<b>marantz®</b> <b>SERVICE BULLETIN</b>		Date: 31-Oct.-2003	Model: SR4300/SR4400
		Page: 1 / 3	REF.NBR: MZ03-047
Circulation:		Subject:	
Application:		The problem of the Speaker protection circuit.	
x for information customer complaint in case of service mandatory .....			
		Service code XE00 XE00xxxxxxxxxx

<b>marantz®</b> <b>SERVICE BULLETIN</b>		Date: 30-June-2003	Model: SR4300,SR4400
		Page: 1 / 1	REF.NBR: MZ03-025
Circulation:		Application:	
x for information customer complaint in case of service mandatory .....		See Below	
		Int.ref:

<b>marantz®</b> <b>SERVICE BULLETIN</b>		Date: 30-June-2003	Model: SR4300
		Page: 1 / 3	REF.NBR: MZ03-026
Circulation:		Application:	
x for information customer complaint in case of service mandatory .....		See Below	
		Subject: Noise is conspicuous by the conditions.	
		Int.ref:

<b>marantz®</b> <b>SERVICE BULLETIN</b>		Date: 28-Aug-2003	Model: SR4300
		Page: 1 / 1	REF.NBR: MZ03-033
Circulation:		Subject:	
Application:		There is a case that the power shut-down suddenly.	
x for information customer complaint in case of service mandatory .....		Int.ref:	
See Below

### SR4300

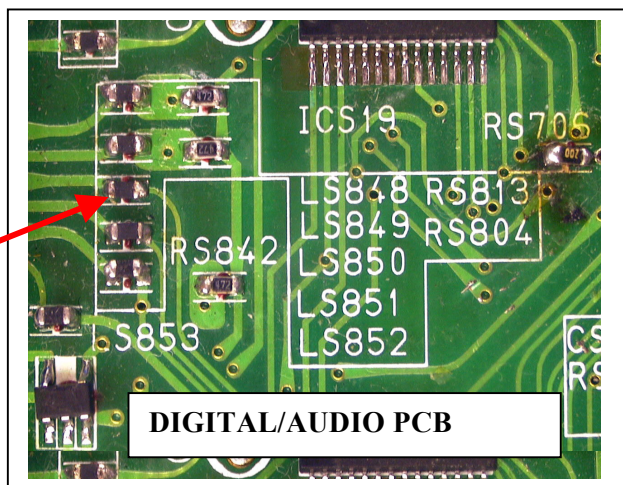
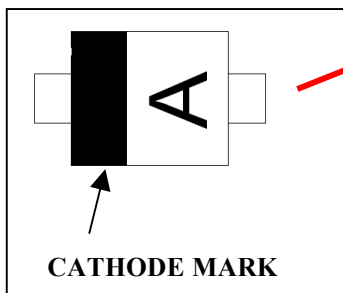
- 1) Chip Resistor **LS850** (100 ohm 1/16W part no. NN05101610 ) is changed to **Silicon Diode (Part no. \*HD201810R--- 1SS400 POHM: EMD2, EIAJ: SC-79, JEDEC: SOD-523 )**.

- 2) Chip Resistor **DN601(Part no.HD20002000---Silicon Diode 1SS254 ROHM)** is added between BASE of QN606 SEMICOM.COMP and No.5 pin of JFN101 Connector

LS850 is changed to  
Part no. \*HD201810R

**Caution**  
JFS08 (FPC CONNECTOR) side is  
CATHODE

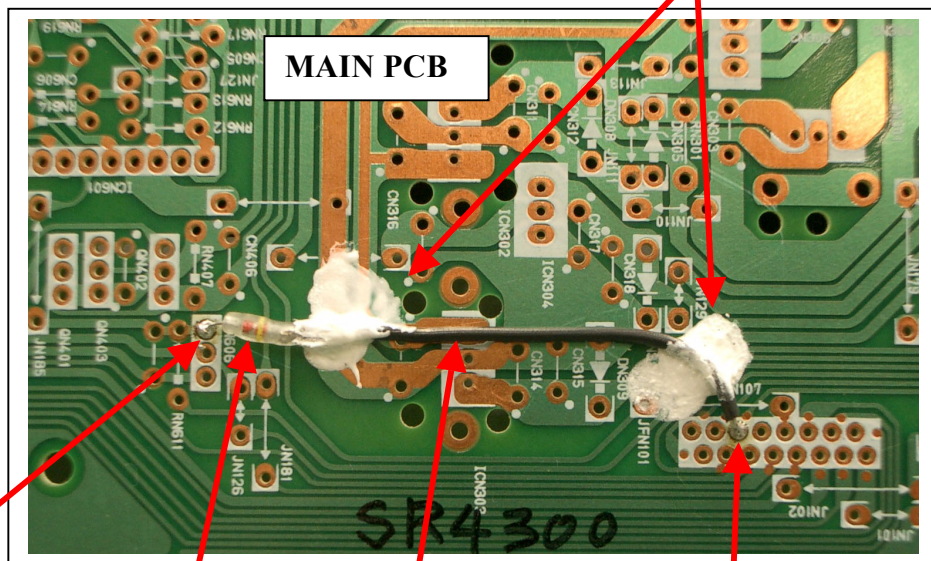
BASE of QN606

DN601  
Part no. HD20002000

No.5 pin of JFN101

Insulation tube is used

**SR4400**

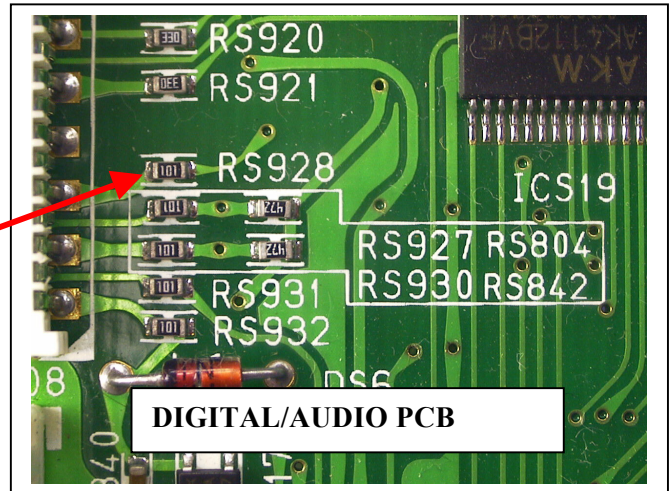
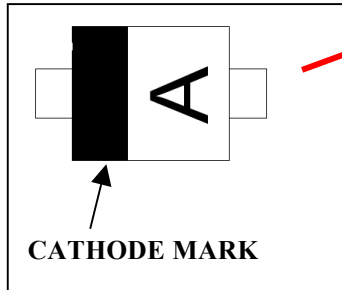
RS928 is changed to  
Part no. \*HD201810R

**Caution**  
JFS08 (FPC CONNECTOR) side is  
CATHODE

BASE of QN606

No.5 pin of JFN101

Insulation tube is used

DN601  
Part no. HD20002000

Fig.1

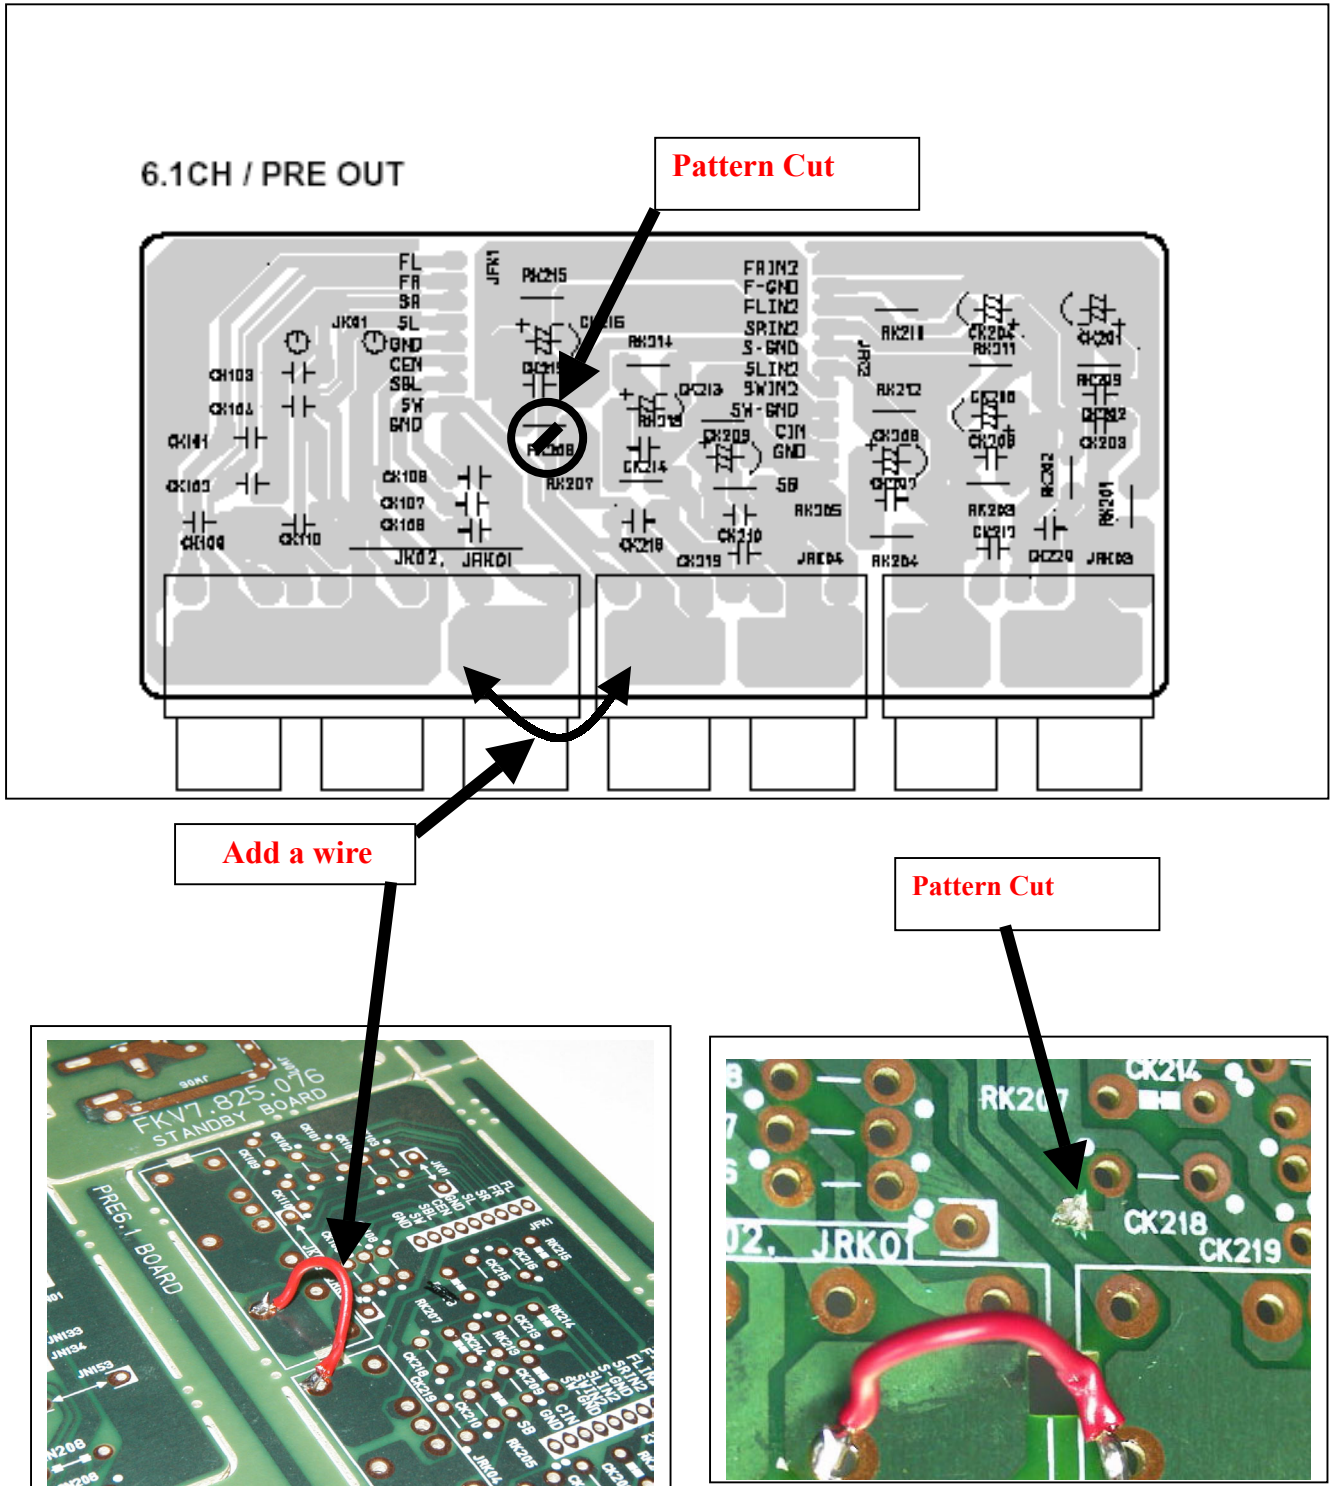
3. Cut a pattern. (please see Fig.1)
  4. Add a wire. (please see Fig.1)
  5. Twist the wire 5 times. (please see Fig.2)
- The 9pin wires are connected to JFS05(DIGITAL/AUDIO PCB) from JFK1(6.1CH/PRE OUT PCB)

Fig.2

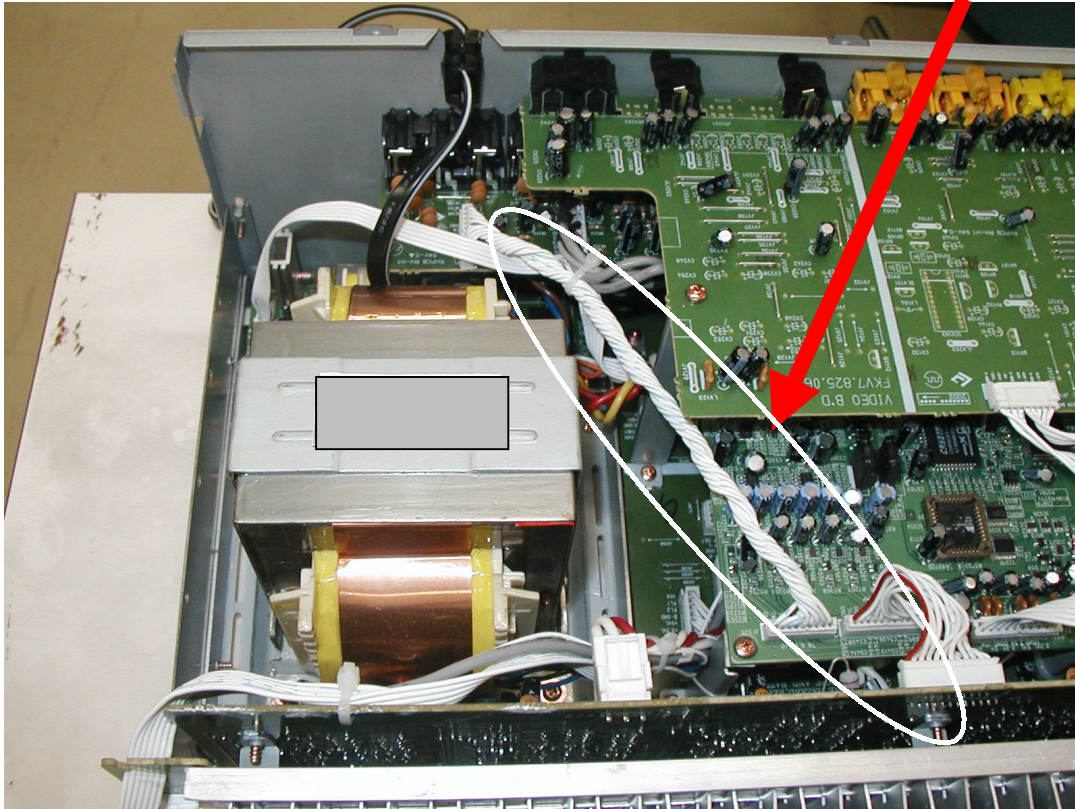
Twist the wire 5 times

RS870 is this side of DIDITAL/AUDIO PCB

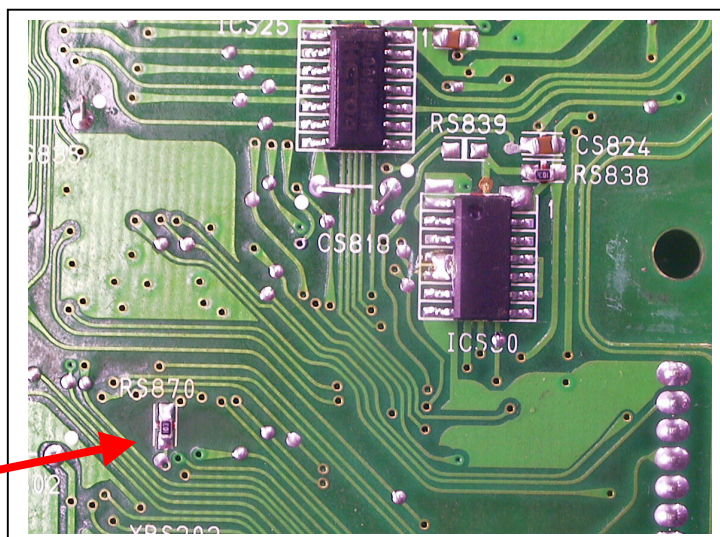
When the unit warms up, CPU clock stops, and the unit becomes a perfect stop.  
The capacitor (0.1uF) was mounted instead of resistor RS870(10 k ohm) .  
(When the PCB is repaired, it has the possibility that a capacitor (0.1uF) was used.)

1. Confirm whether **RS870** on DIGITAL/AUDIO PCB is **10 k ohm Chip resistor**.
2. The part which isn't right, changed to **10 k ohm Chip resistor (Part no. NN05103610)**.

RS870 (10 k ohm)

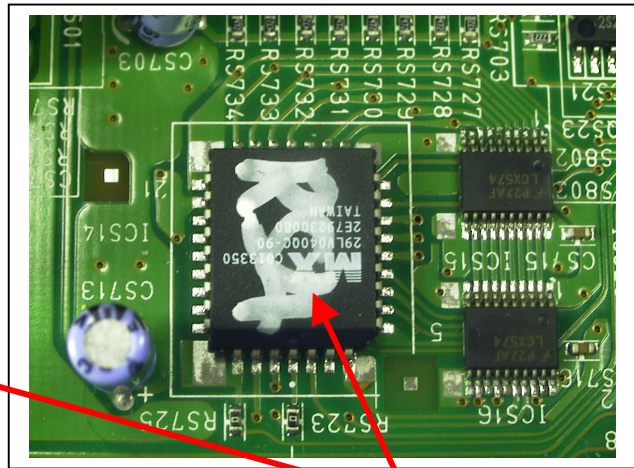
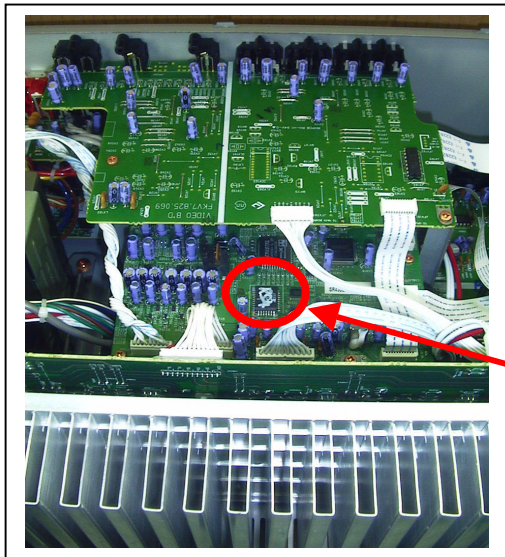
Treble is slightly distorted when the level of TruBass is increased in CSII mode. (only in case of Rch)

It occurs when “Speaker Size setup” is set as the right figure.

Replace IC (ICS14) on the **DIGITAL/AUDIO CIRCUIT BOARD**.
